EPC STORMWATER REVIEW COMMENTS
IN ORANGE BOXES WITH BLACK TEXT

Cathedral Rock Commons Commercial Grading & Erosion Control Plans El Paso County, Colorado

GEC PLAN
TITLE SHEET

GENERAL NOTES

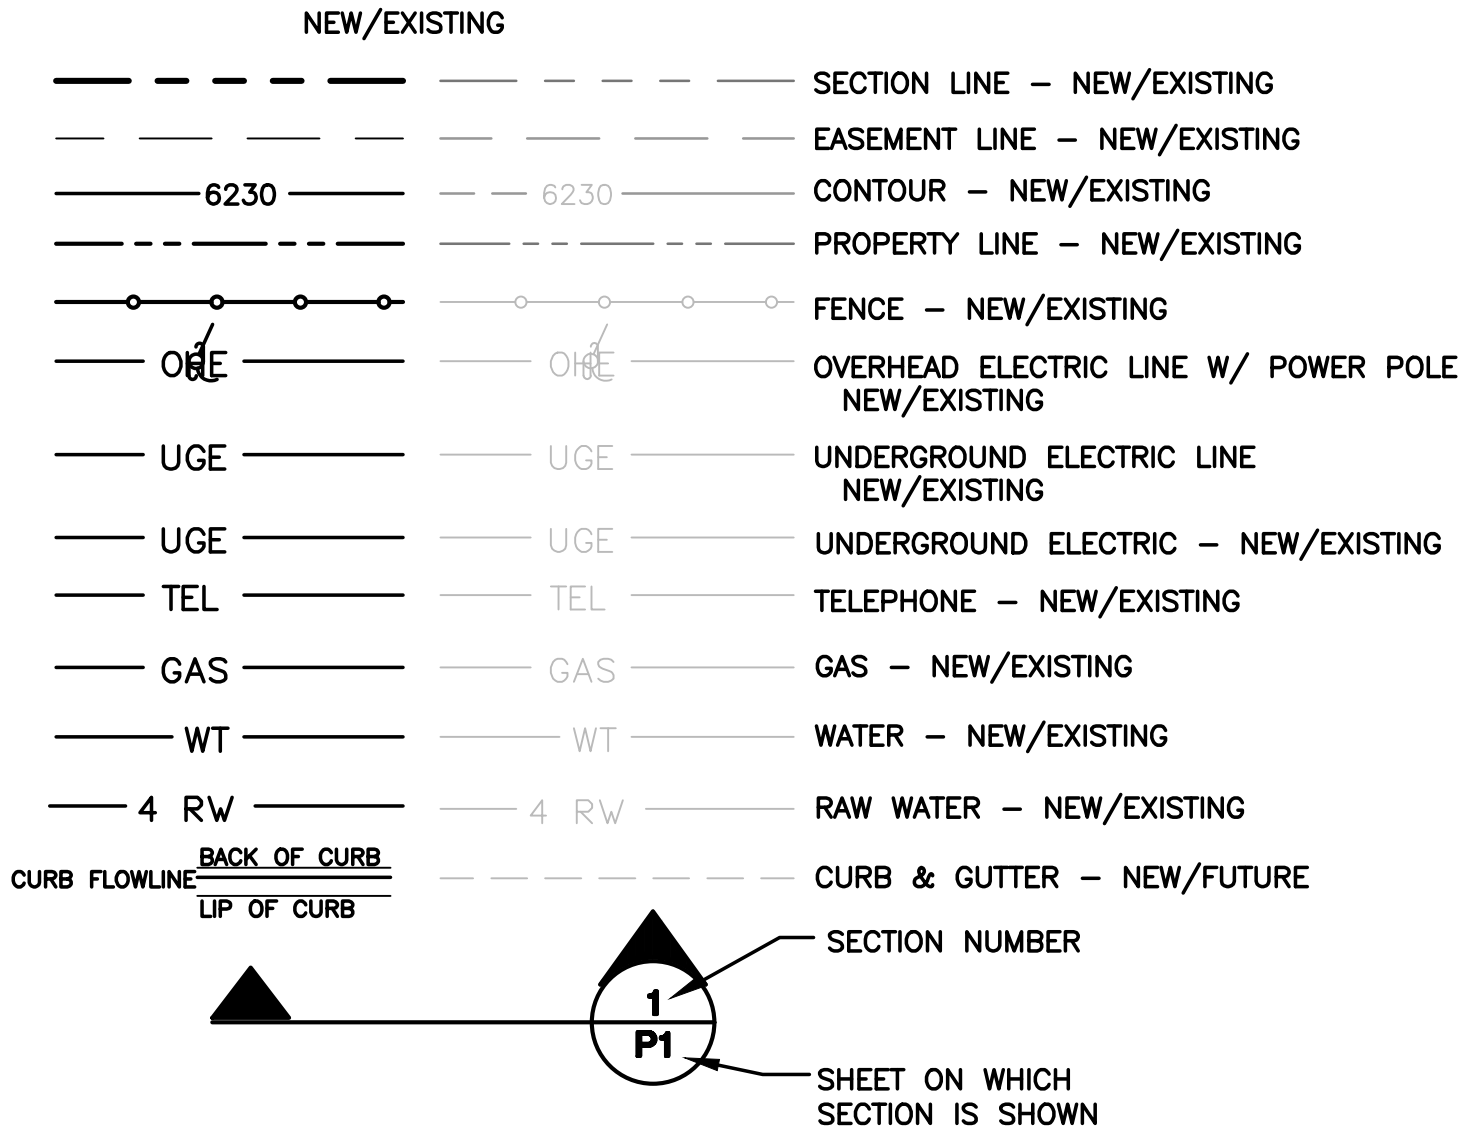
This cut/fill linetype not seen on plans. Show it per Checklist Item "p"

Items H and M. On plans and Legend, label "limits of disturbance" and "construction boundary." If they are the same, change to "limits of construction/disturbance" or otherwise show as separate line types for each on the legend and figure.

EROSION CONTROL
NOTES & DETAILS

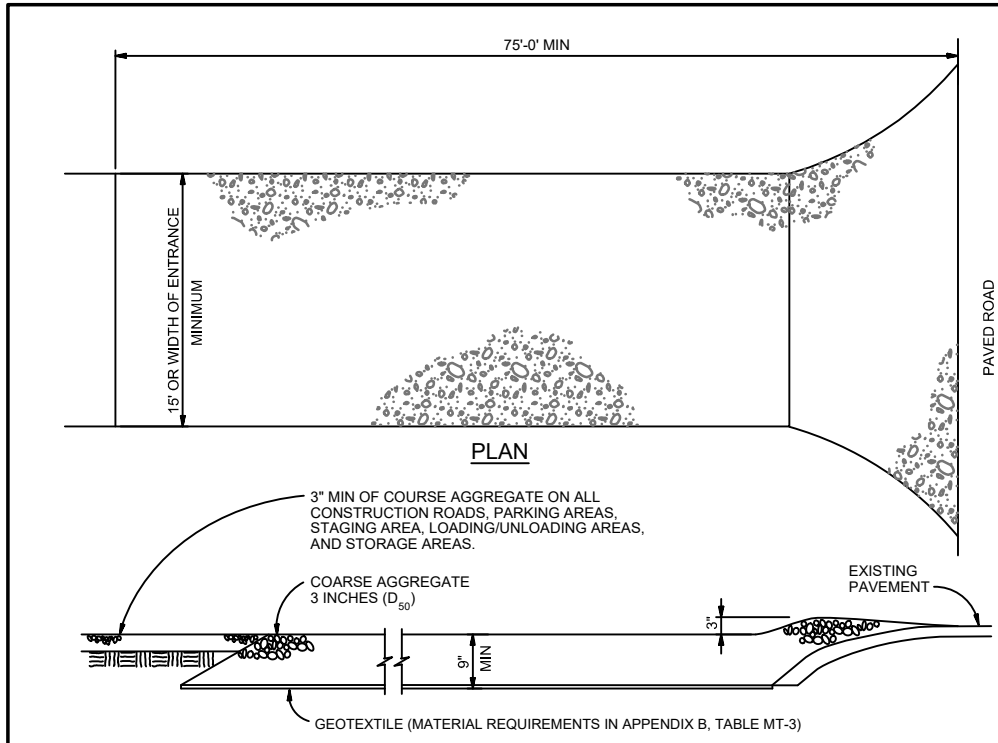
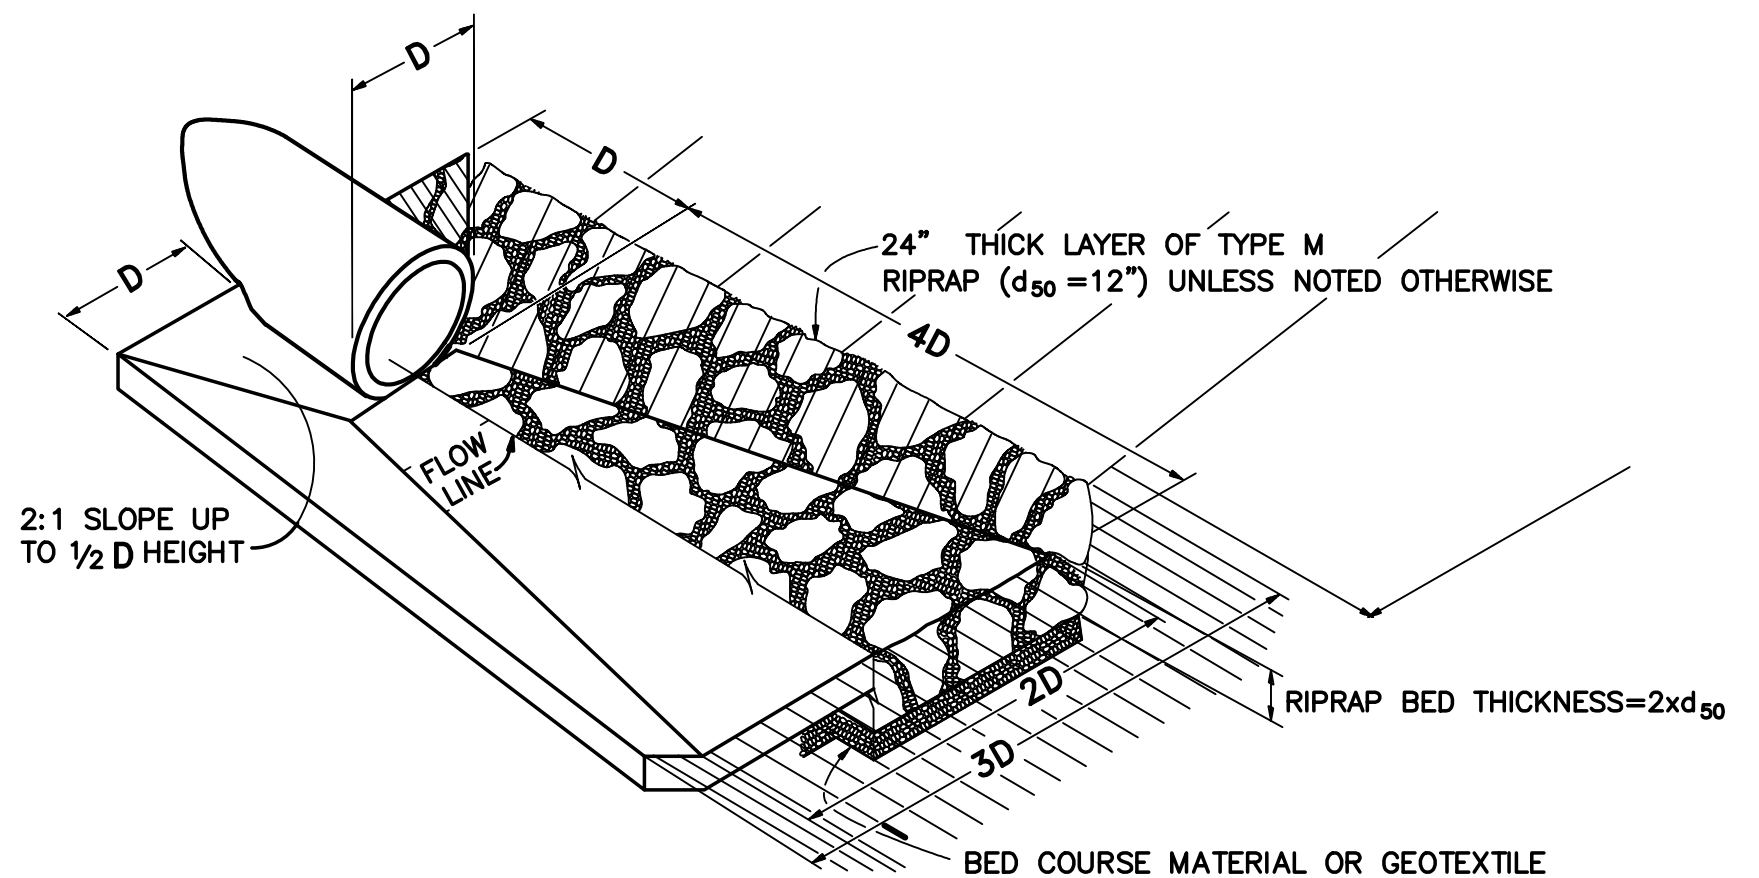
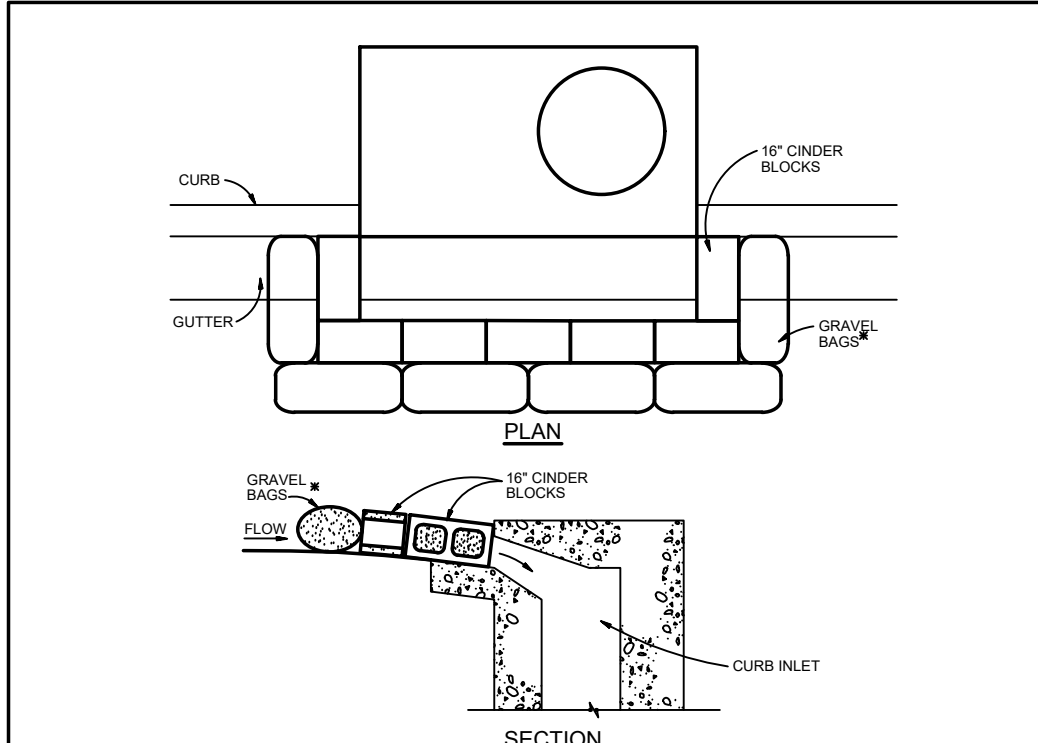
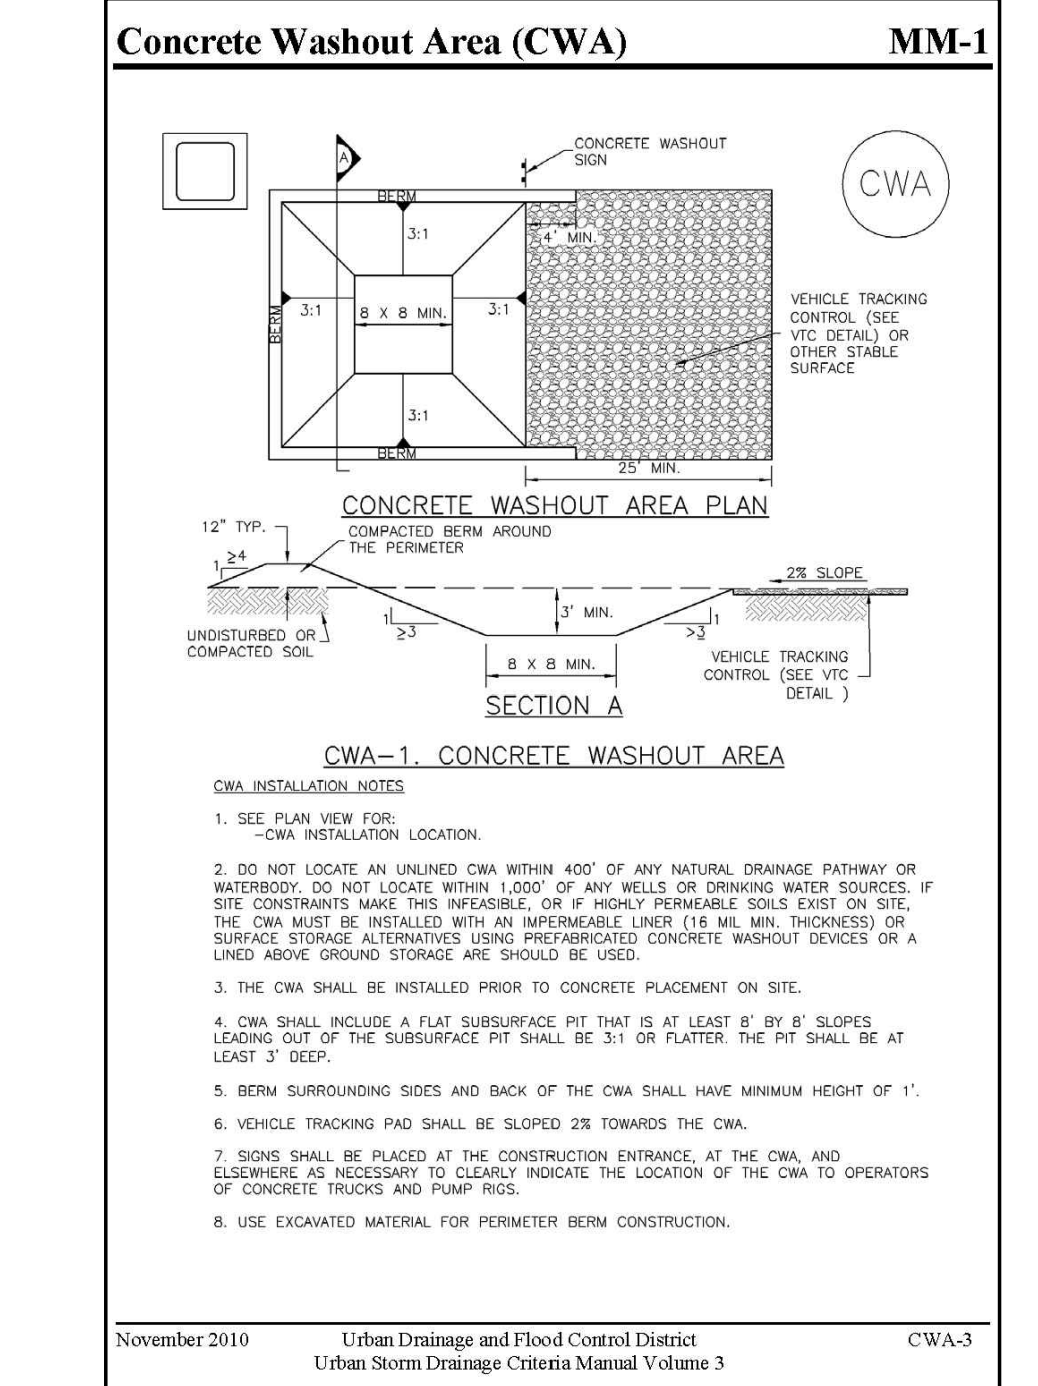
The ESQCP has a 2022 start date. Revise this or the ESQCP to remove scheduling discrepancies.

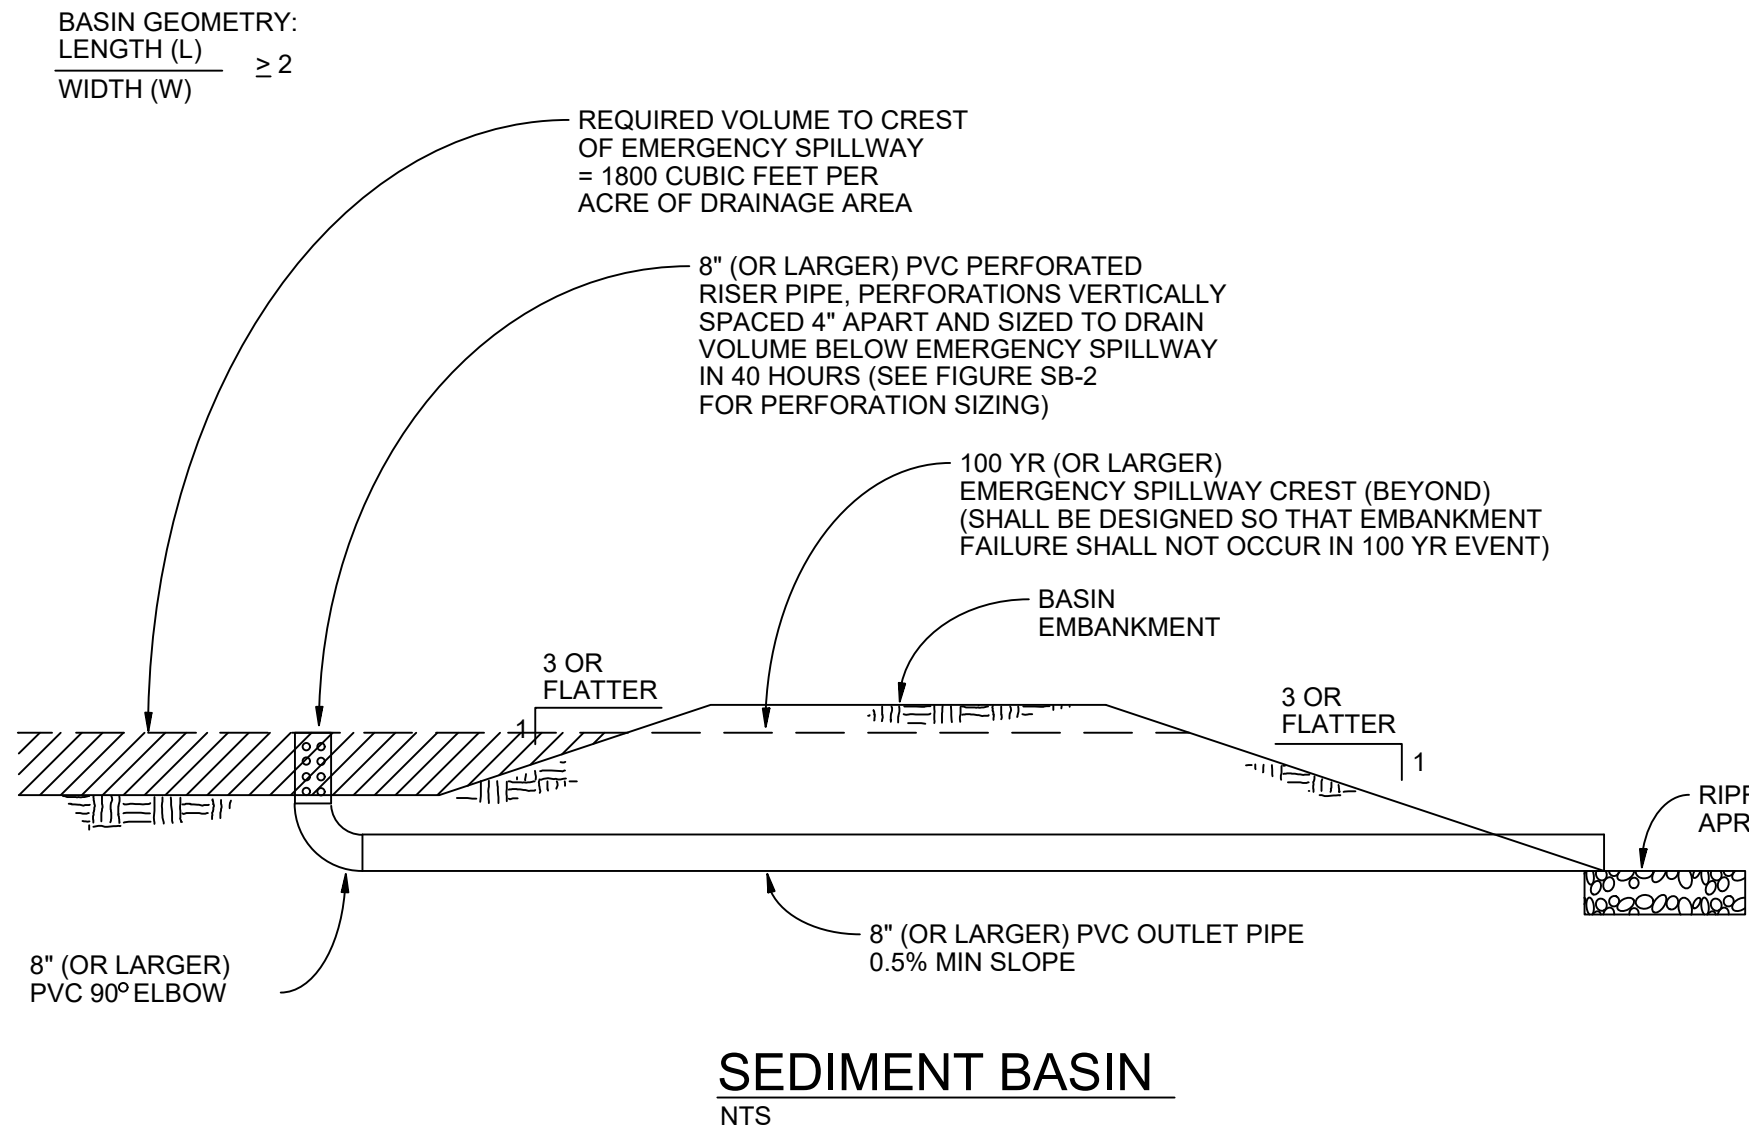
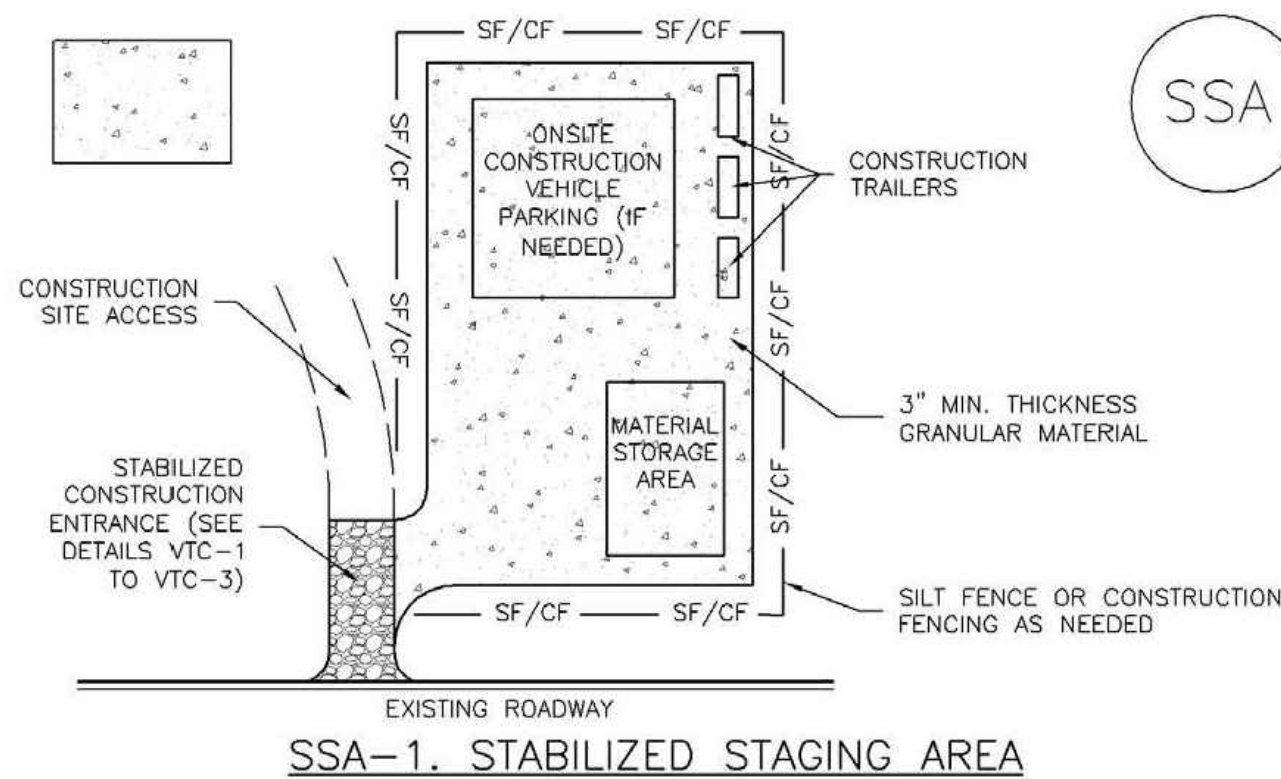
Item Z. Include details for the following BMP's. Examples of acceptable details for each are provided:

BMP	Detail # and Source		
	DCM (Vol 2: Chap 3.3)	MHFD (USDCM Vol 3: Chap 7)	COS - Stormwater Construction Manual (App E)
Mulching	MU-1	EC-4	X
